# PLANNING DIRECTOR'S SPECIAL PERMIT

APPLICATION: Planning Director's Special Permit to allow one additional dwelling unit under the deep lot provision of the Zoning Ordinance.

LOCATION: 530 Lampasas Avenue

PROPOSAL: The applicant is requesting the necessary entitlements to move an additional single-family dwelling unit on a lot 194 feet in depth.

EXHIBIT A

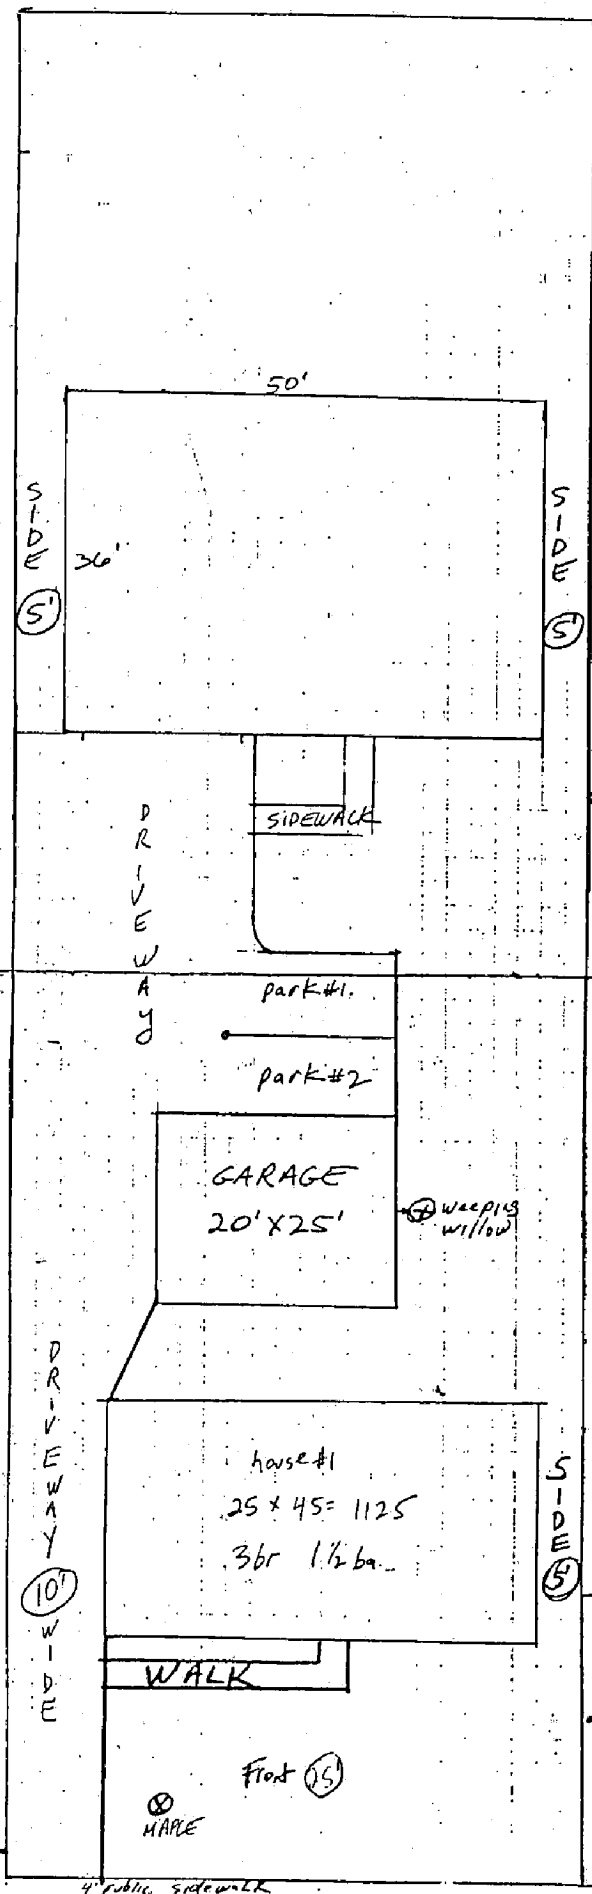
The applicant proposes to locate the front unit 25 feet from the front property line. The detached two car garage will be located 10 feet south of this unit and fifteen feet from the east property line. Two additional parking spaces are proposed to the south of the detached garage with fifteen feet of maneuvering width. The rear unit is proposed to be 37 feet to the south of the parking spaces and 40 feet from the rear property line. A six foot wood fence is proposed along the east, south and west property lines. (Exhibit A).

**REVISED PLAN**  
**STAFF EXHIBIT B**

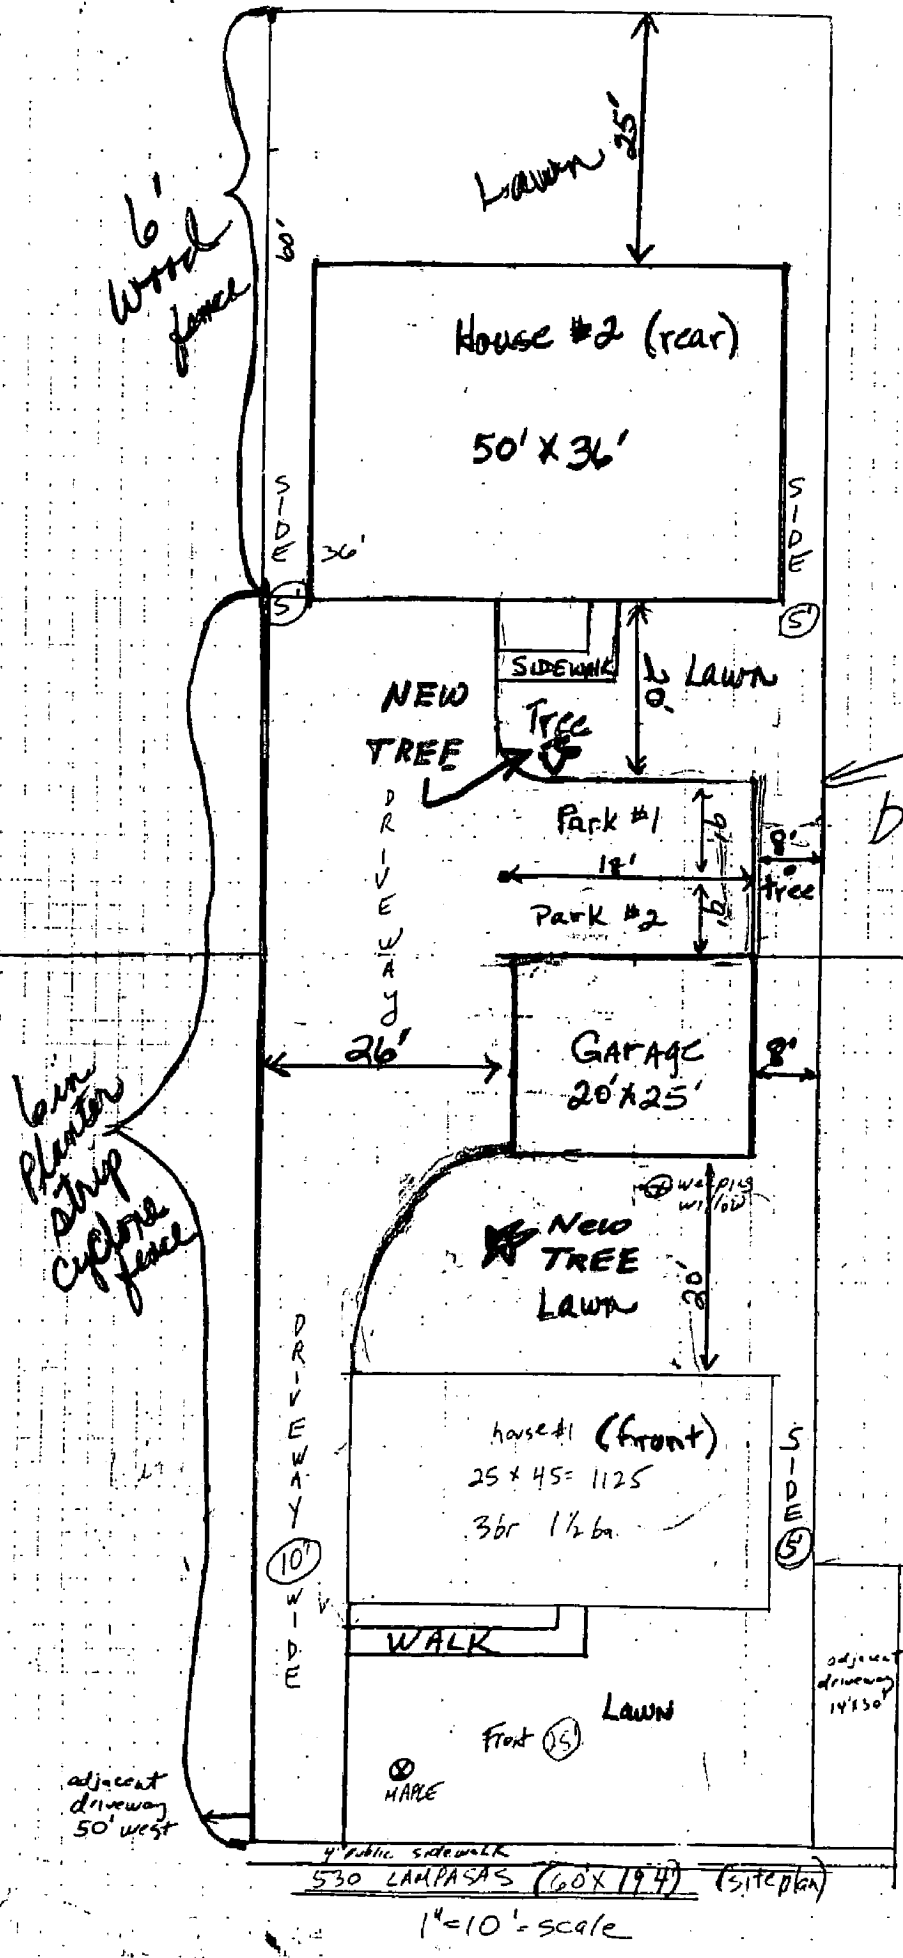
Staff recommends that the detached garage be located 20 feet south of the front unit and 8 feet from the west property line. This will allow adequate maneuvering (26 feet) in front of the garage and more usable rear yard space for the front unit. The applicant should also increase the lawn area to the east between the garage and the front dwelling unit. Staff has spoken with the City Arborist concerning the weeping willow tree located on the site. The arborist has recommended removing this tree due to its poor condition. The applicant should replant a tree in this area (between the front unit and detached garage).

The rear unit should be located twenty-five feet from the rear property line, this will allow adequate rear yard area which will require less maintenance. The applicant should install automatic sprinklers in all lawn and planter areas. Staff further recommends planting two additional trees on the site. One located between the west property line and the parking

spaces, and one along the driveway between the parking spaces and rear unit, in order to provide some relief from the amount of concrete used on the site.

Staff suggests the applicant install a cyclone fence along the east property line down the driveway to the rear unit. A six inch planter strip, irrigated and planted with climbing vines should be placed along the fence in order to provide some landscaping relief along the driveway. The applicant should install a six foot wood fence along the remainder of the east (approximately 60'+), south and west property line. All fences must meet zoning ordinance standards, three feet in front setback area and six feet high once outside the setback area.

1. The detached garage shall be located 20+ feet from the front unit and 8 feet from the west property line to allow for adequate yard and maneuvering area.
2. A 15 gallon tree shall be planted between the detached garage and the front unit to replace the weeping willow tree.
3. Two 15 gallon trees shall be planted between the west property line and the parking spaces and along the driveway between the parking spaces and rear unit.
4. Automatic sprinkler system shall be installed in all lawn and planter areas.

5. A cyclone fence shall be installed along the east property line along the driveway to the rear unit. A six inch planter strip, irrigated and planted with climbing vines shall be placed along the cyclone fence.

6. The fence on the west, south and the remaining 60± of the east property line shall be a 6' high wood fence.
7. The rear unit shall be located 25 feet from the rear property line.

EXHIBIT D

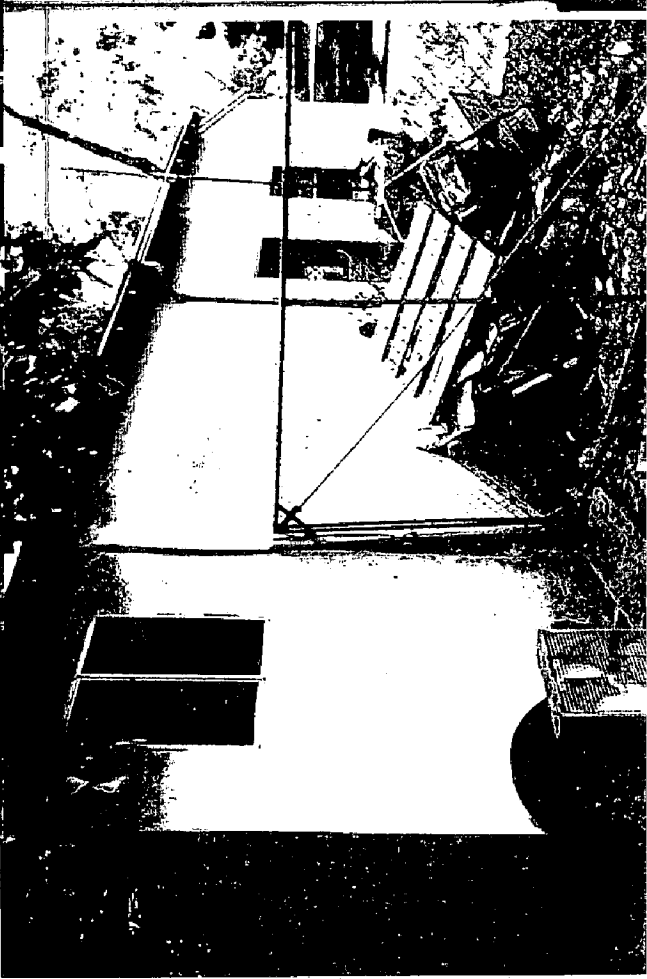
The applicant proposes to move two residential units onto this lot. The rear unit is stucco with a composition roof. Staff finds that this unit is compatible to the surrounding neighborhood.

EXHIBIT E

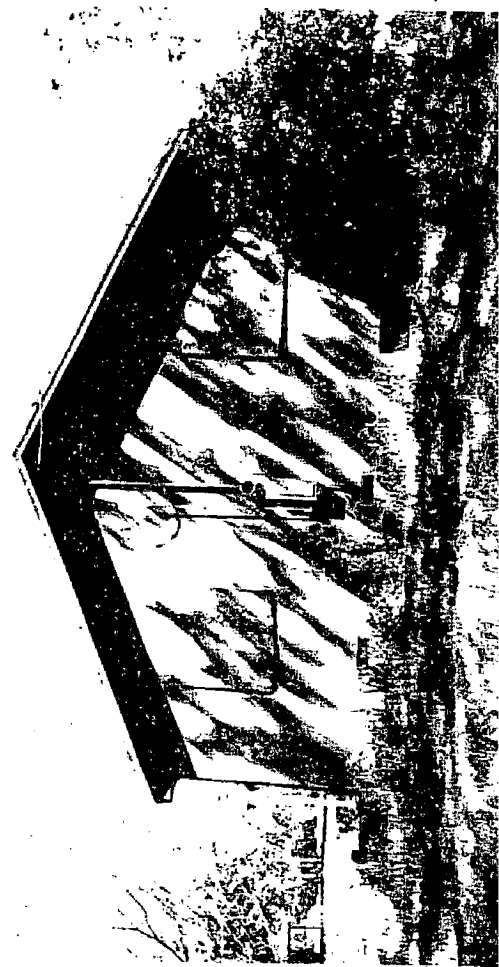
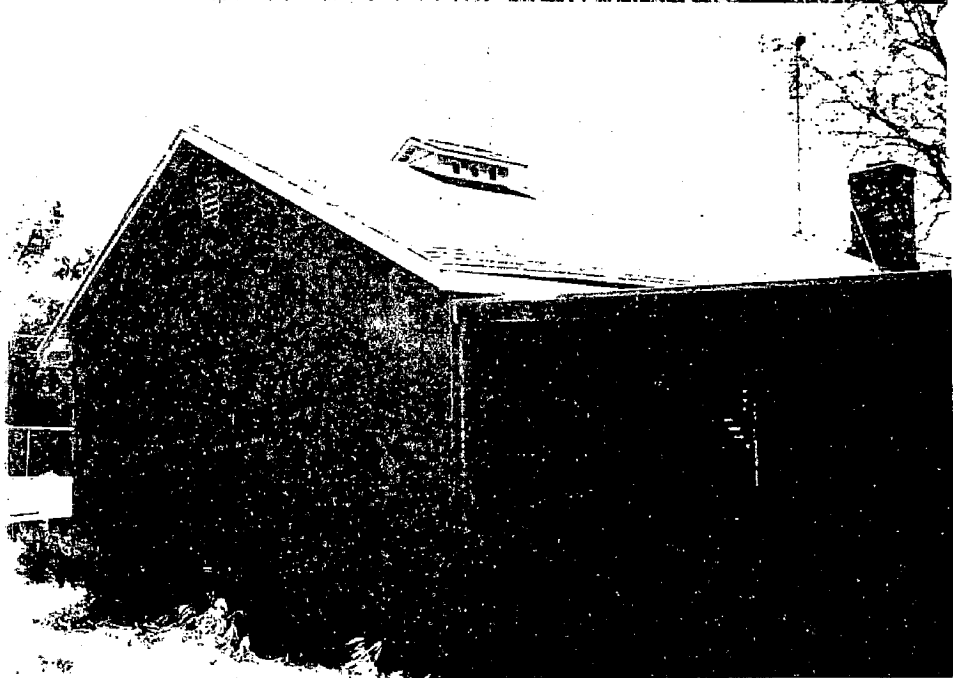
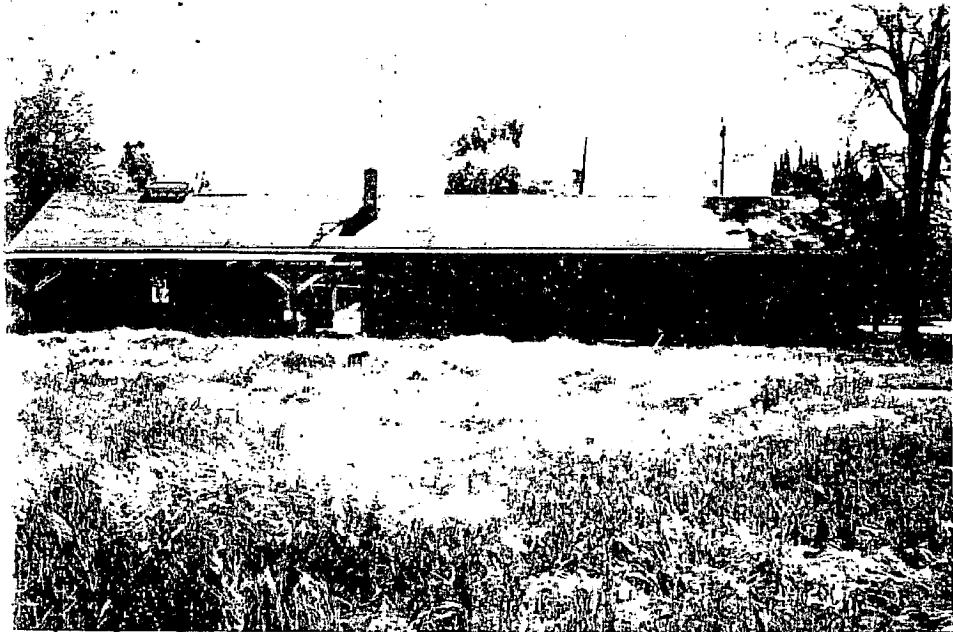
The front unit currently is a single family unit with a garage connected by a breezeway. There is a covered walkway from the breezeway to the front door. This portion of the front elevation consist of a brick and wood siding facade. When the unit is moved to Lampasas Avenue, the walkway will be shifted to the opposite side. Therefore, staff suggests that the roof overhang (covered walkway) and the brick and siding on the front elevation be extended across the entire front of the unit towards the driveway. This would improve the overall appearance of the front elevation.

8. The roof overhang (covered walkway) and the brick and wood siding shall be extended across the entire front elevation of the front dwelling unit.
9. The parking spaces shall have a 6 inch x 6 inch poured in place concrete bumper curb.
